Leckwith Quays
Applicant Response to Vale of Glamorgan Landscape Officer Comments
Planning App. Ref. 2020/01218/HYB
Phil Worthing – instructed by Gareth Davies Project Services Ltd

May 2021

Proposed Sections S301A

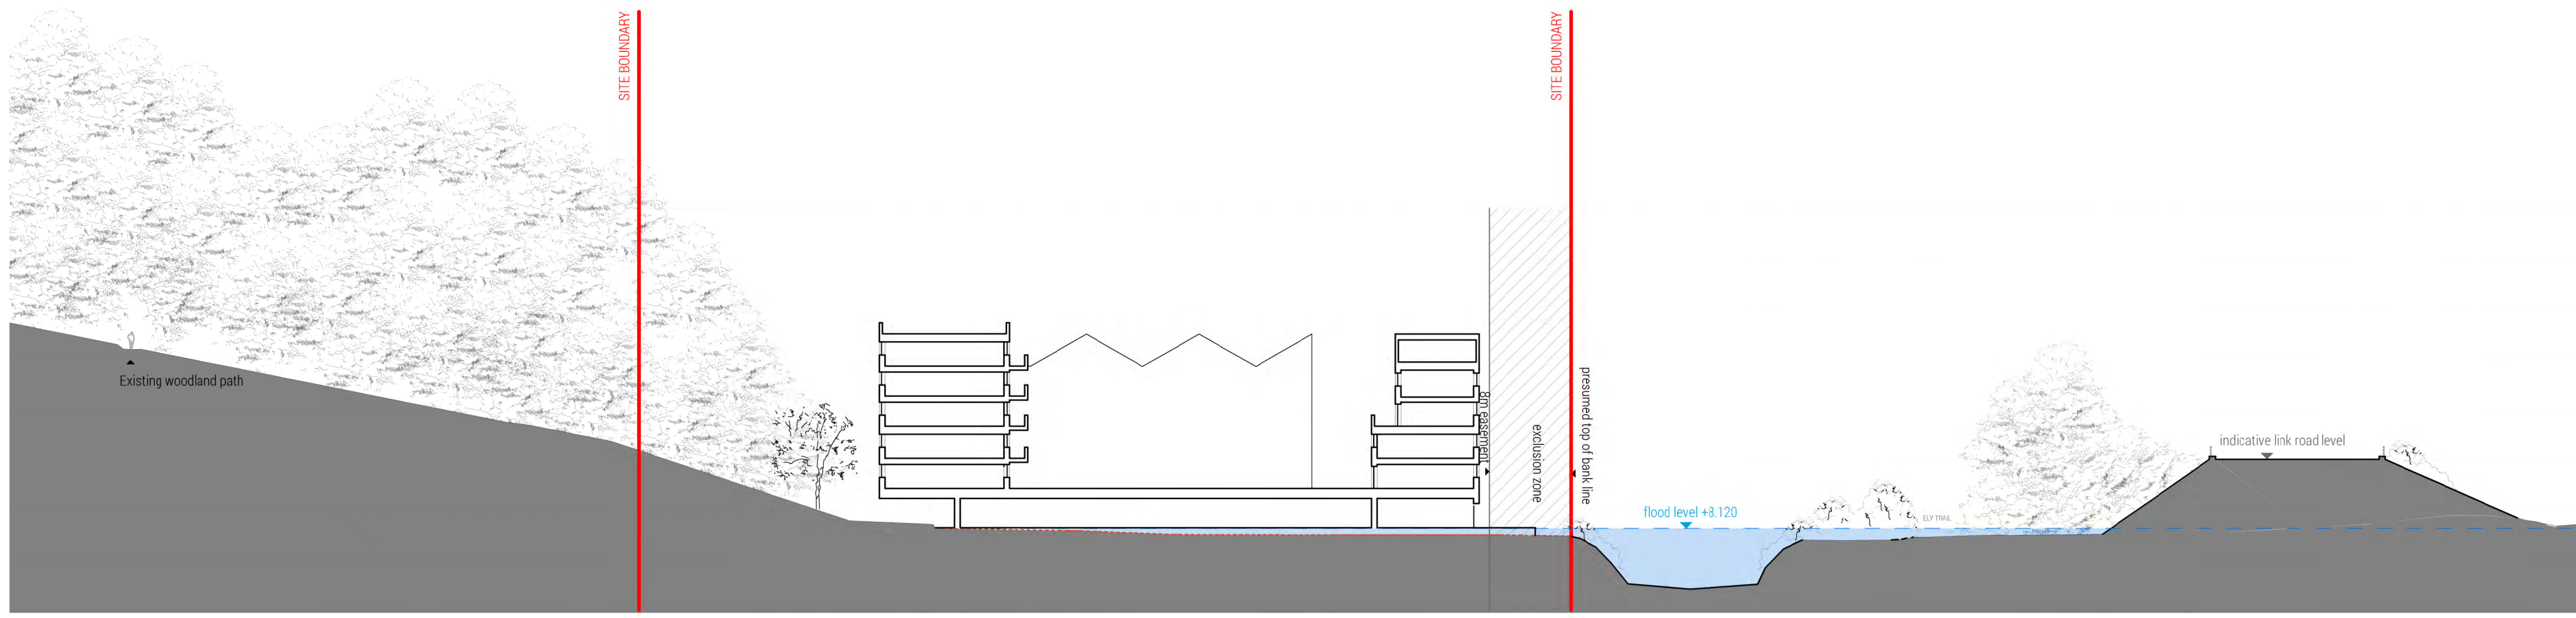
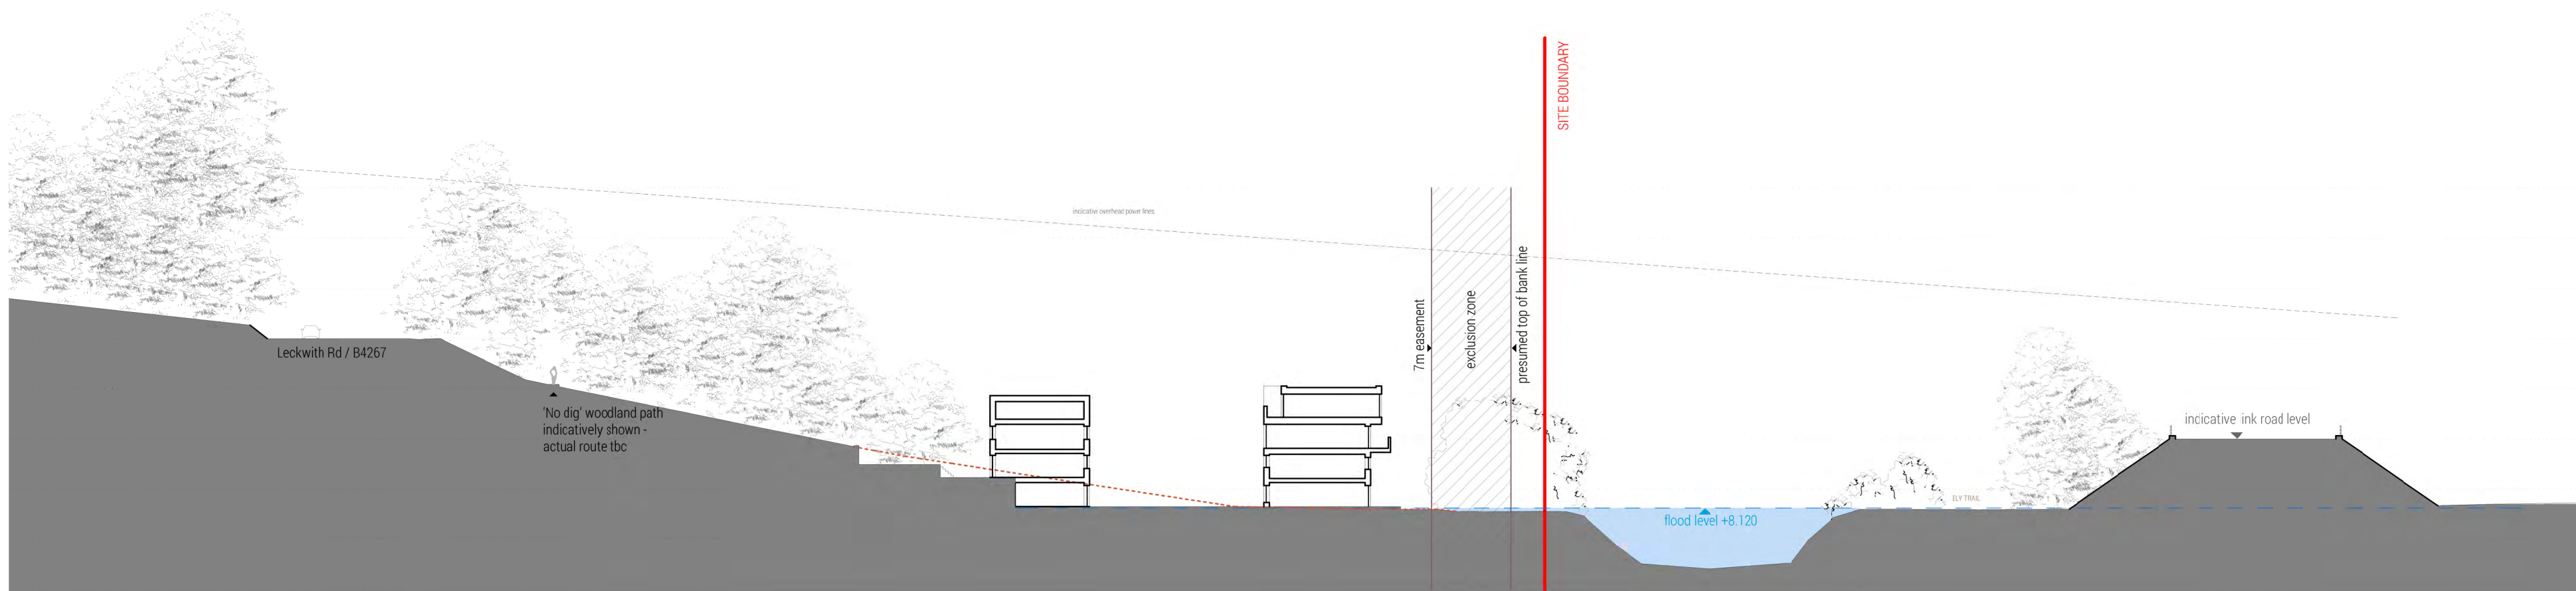
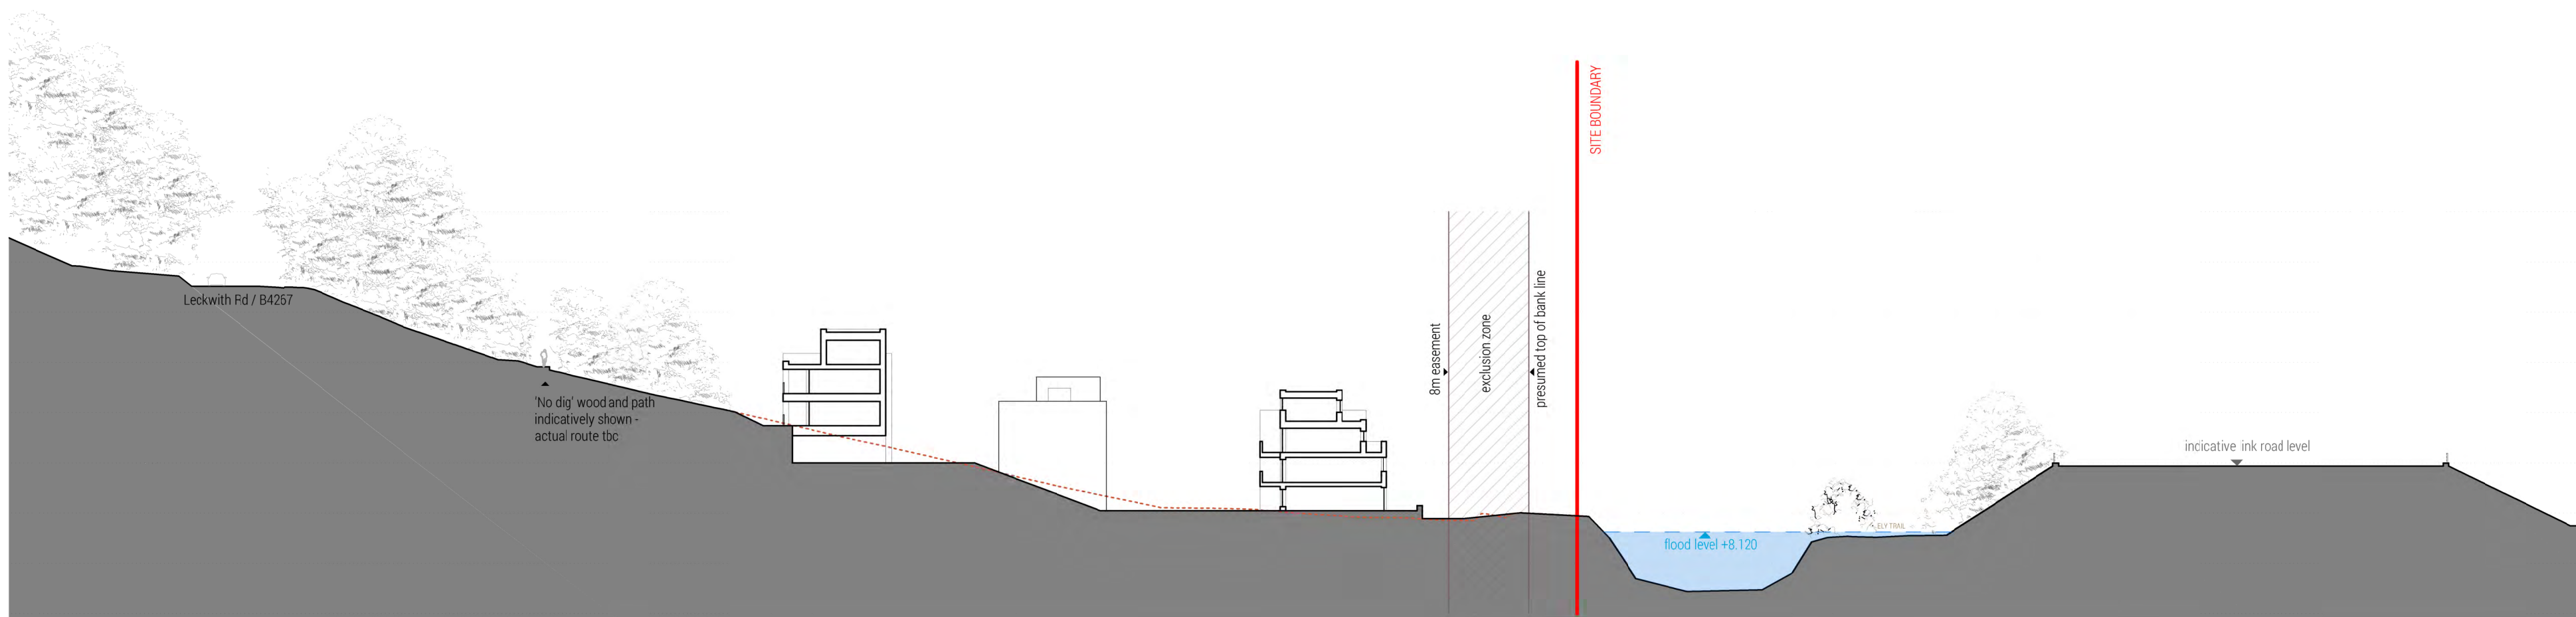
Comment 7

Cross sections through the whole development would be useful to aid understanding of the proposal. At present the sections only show the buildings and not their relationship with the proposed road or woodland path

We can confirm that this work has been carried out by Loyns & Co Architects, see drawing S301A 3 (see Appendix B).

REVISIONS:
A - 08.03.21 - DRAWING UPDATED TO CLEARLY SHOW
LECKWITh ROAD AND WOODLAND PATHS
